# City of Stevenson

## December 2023 Planning Commission Meeting

#### 4. Shoreline Permit Request: (SHOR2023-01 Rock Cove Hospitality)

Figure 1  
 EXISTING CONDITIONS  
 Rock Cove Addendum  
 FDM Development  
 City of Stevenson, Skamania County, Washington  
 Section 1, Township 2N, Range 7E, W.M.

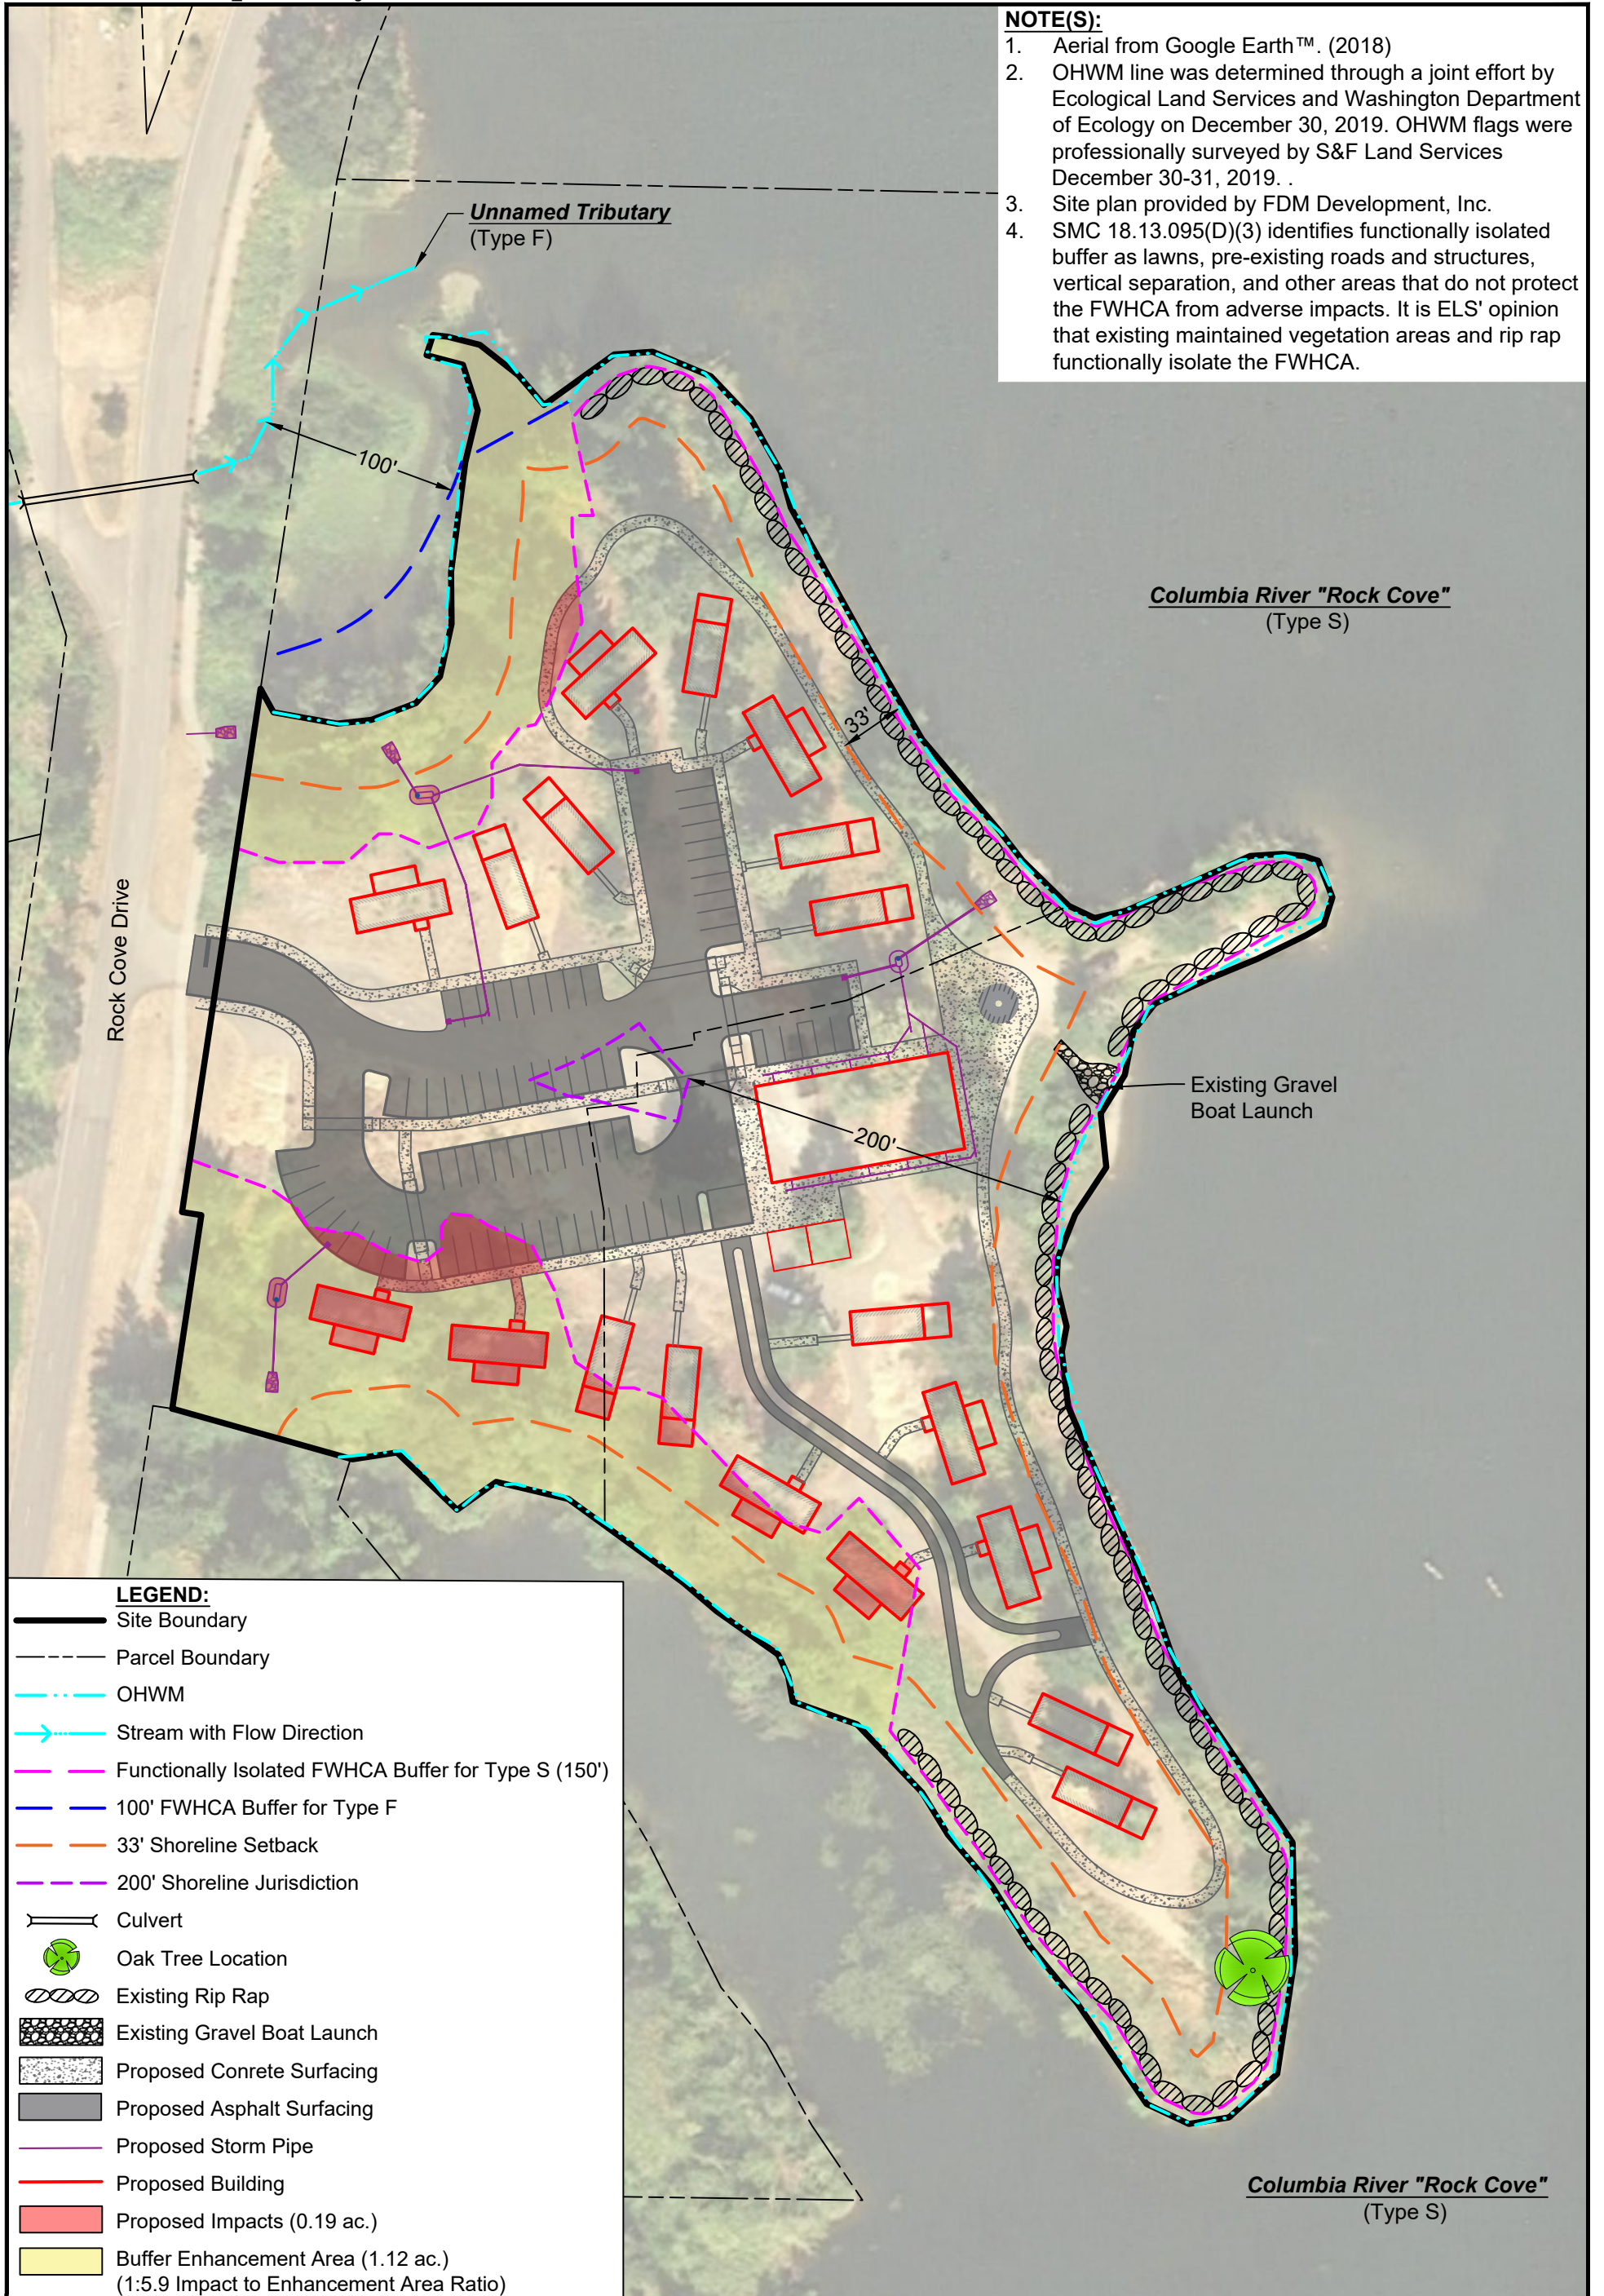
- *Ecology does not think the maintained vegetation areas shown in Figure 1 should qualify as functional isolation.*  
According to the SCO 18.13.095(D)(3), lawns and other mowed areas can be considered as functional separation from FWHCA buffers. These areas have been mowed and maintained since the year 2000 as can be seen on Google Earth aerial imagery. Additionally, these areas were photographed in January of 2020 in preparation of the original draft of the critical areas report by ELS (Photoplate 3 and 4). It is ELS' opinion that the provided evidence meets the requirement in the SCO and that these areas do indeed meet the definition of functional isolation.

Figure 1  
 EXISTING CONDITIONS  
 Rock Cove Addendum  
 FDM Development  
 City of Stevenson, Skamania County, Washington  
 Section 1, Township 2N, Range 7E, W.M.

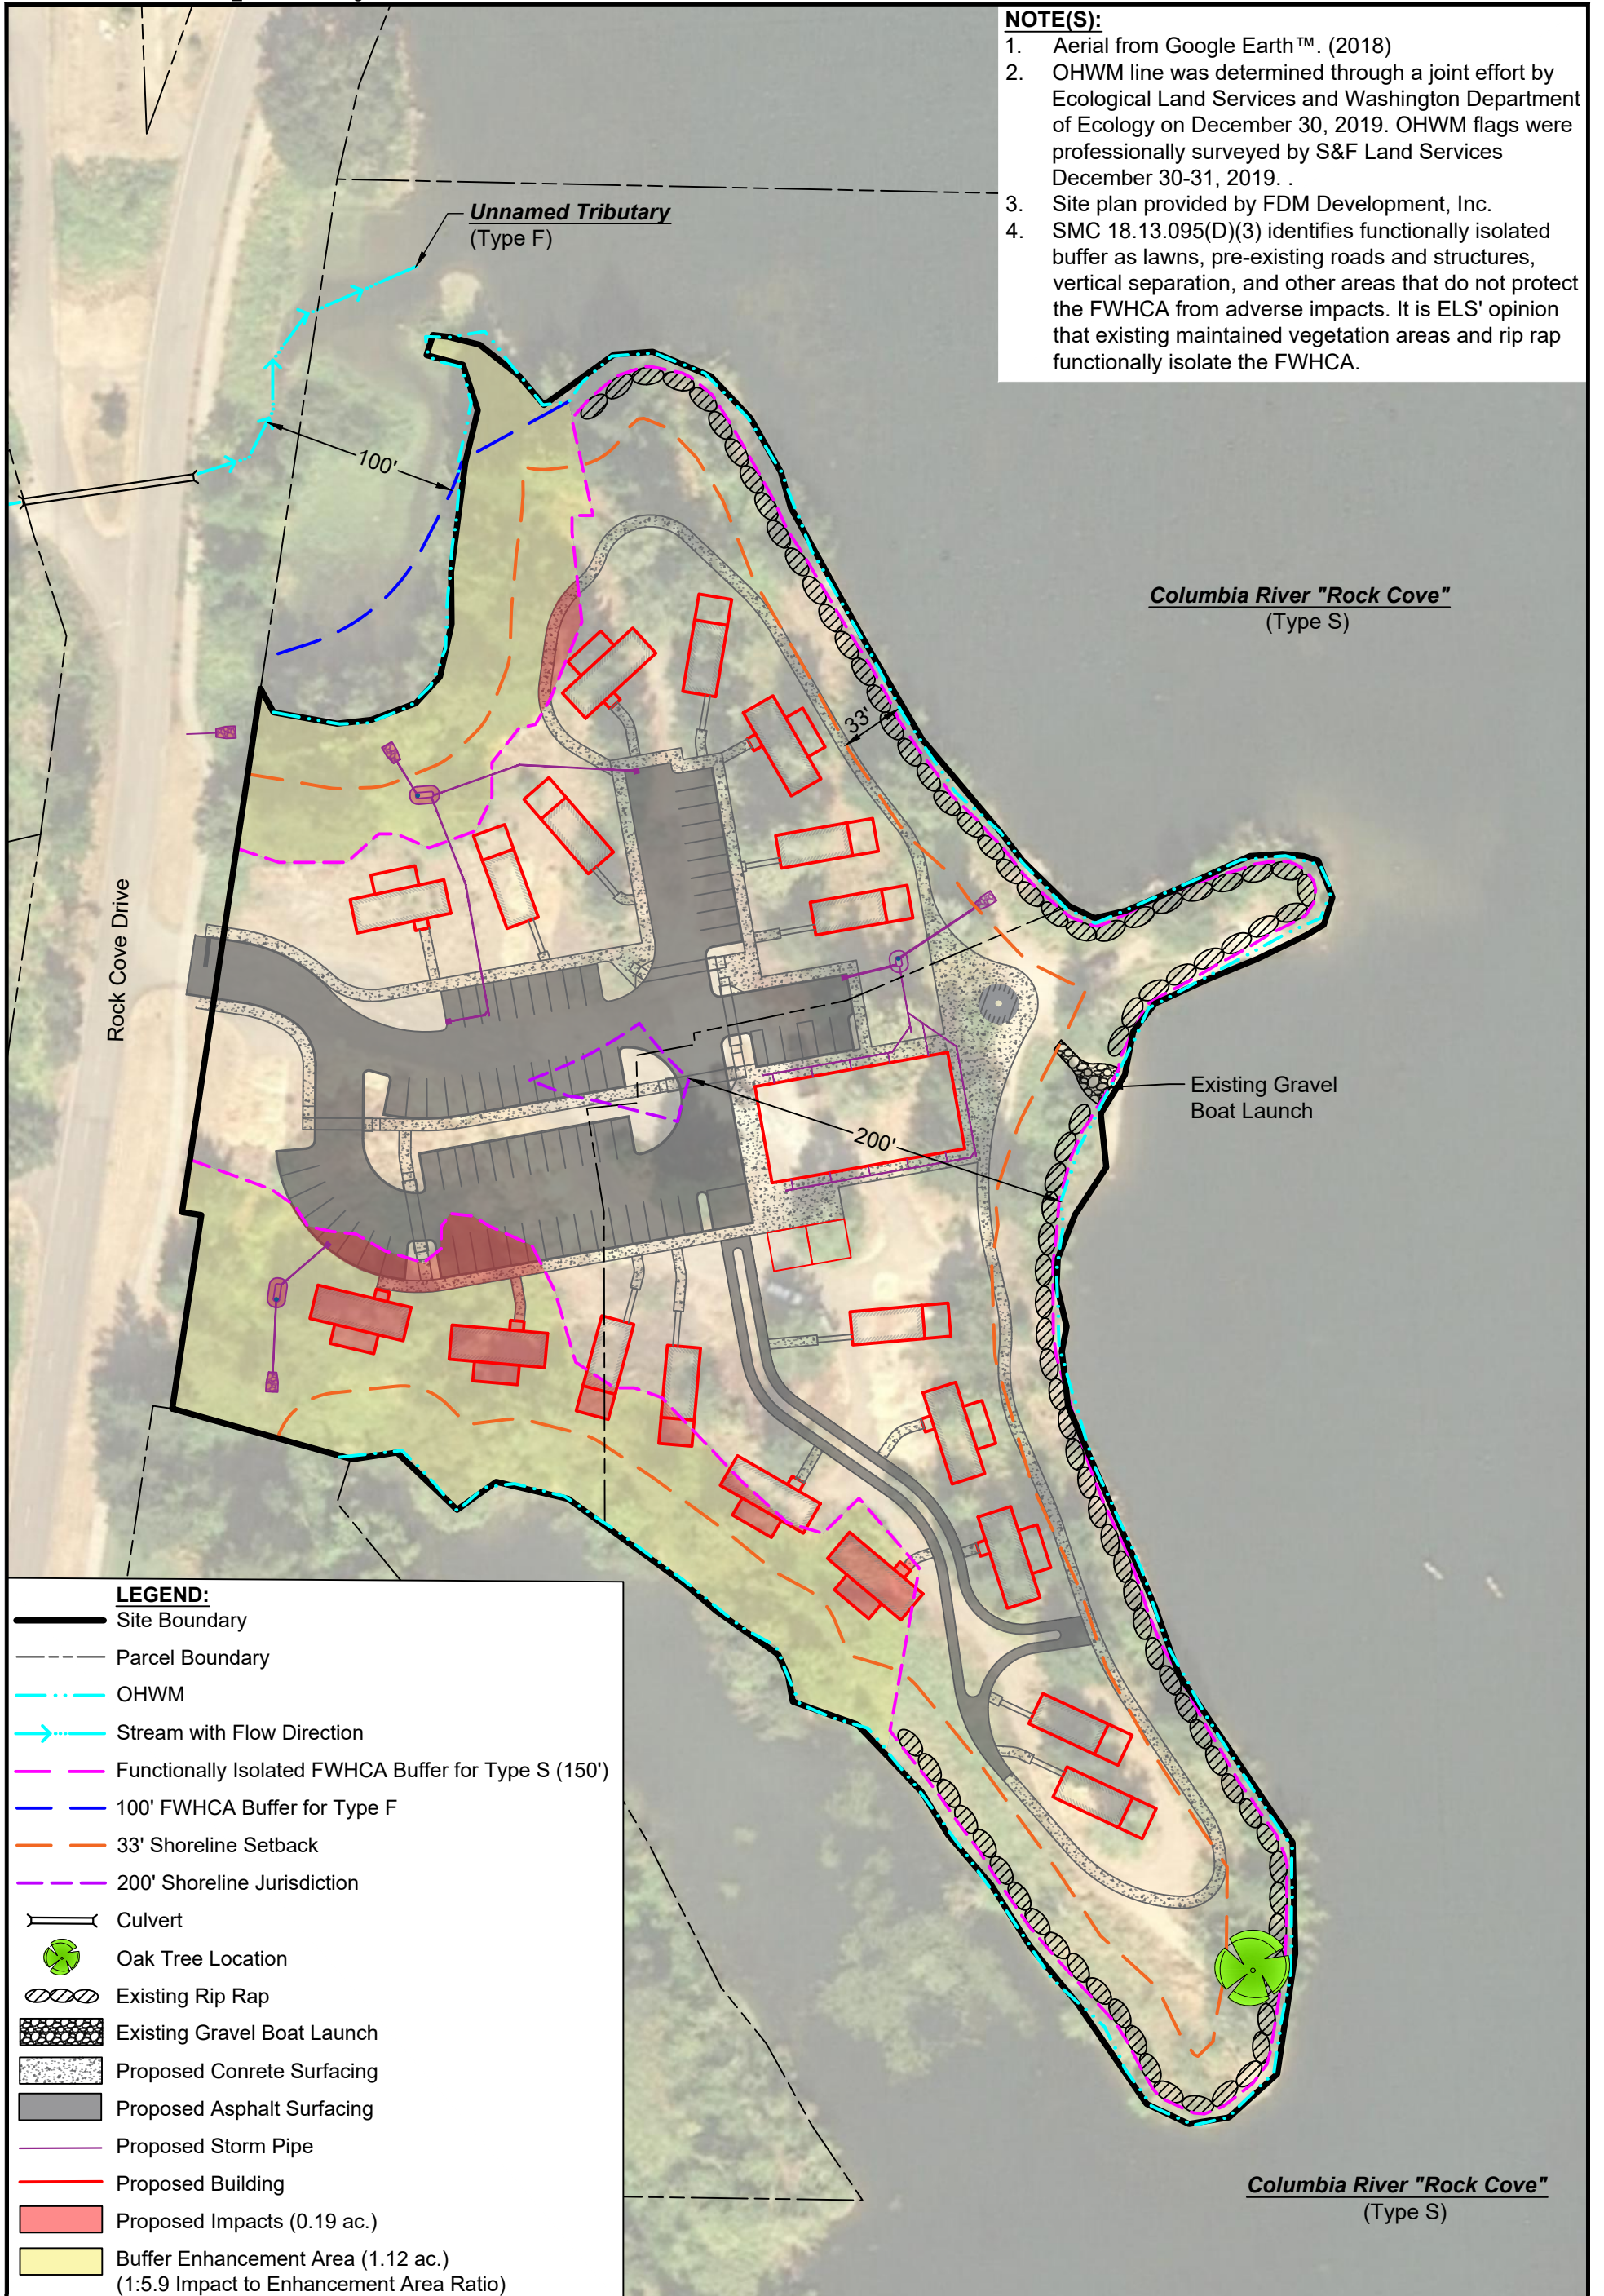
- *Ecology does not think the maintained vegetation areas shown in Figure 1 should qualify as functional isolation.*
